***SERVICE BULLETIN 008: XT-912/582 REAR HUB AXLE INSPECTION***

Identification	SB-008
Status	Mandatory
Issue	1
Issue Date	September 2009
Applicability	All XT Aircraft
Compliance	At or before 100 hours of operation.

**Figure 1 Photograph showing crack**

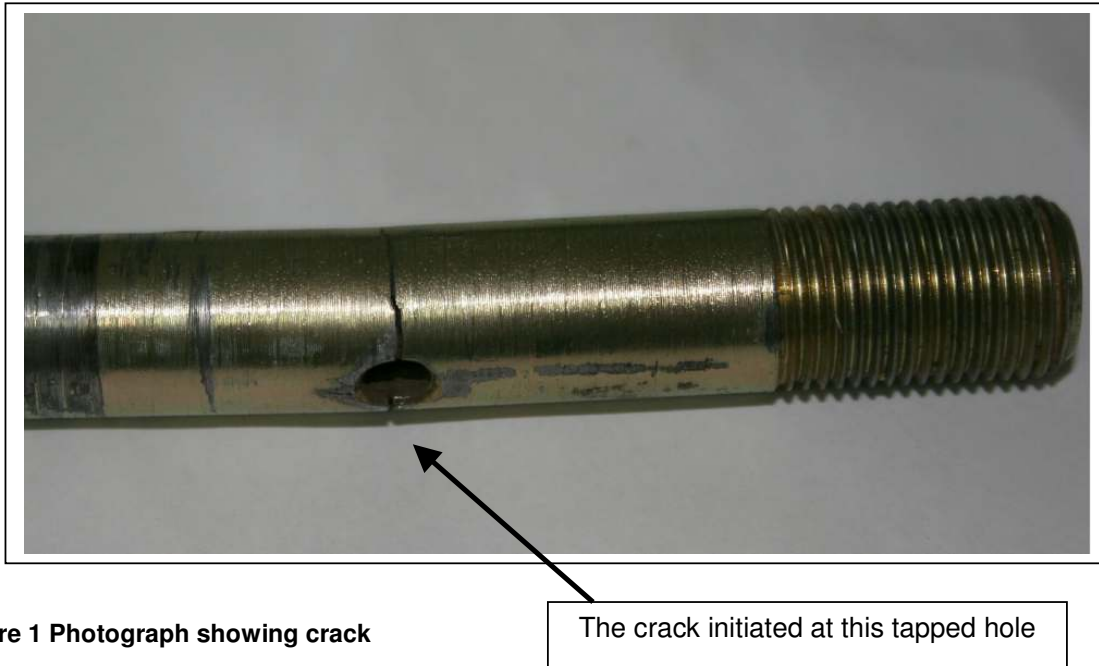
It has been brought to the attention of Airborne that a rear axle - Airborne part # 108452 - HUB AXLE EDGE XT TYPE 2, has been found to be significantly cracked at the tapped locking bolthole. The aircraft involved was a XT 912 tourer edition with approximately 250 service hours.

The crack initiated at this tapped hole

- Remove, clean and inspect the axles after each 100 hours, and during tyre changing.
- A 10 x magnifying glass should be used to aid this inspection.
- Any cracks however small are reason for replacement of the component.
- Repeat this process each 100 hours, as well as each time tyres are replaced.
- Any cracked components should be reported to Airborne Windsports to aid service history.
- Conduct an inspection according to the checklist (Chapter 20 – Standard Practices Airframe).
- Complete a service note in the aircraft logbook.
- It is suggested that if a crack is found in one axle then both should be replaced at the same time.

Any cracking observed during inspection is reason for replacement of:

- The original part # 108452 - HUB AXLE EDGE XT TYPE 2, (Hollow Axle)
- New part # 109012 - HUB AXLE EDGE XT TYPE 3 ZINC PLATED, (Solid Axle)
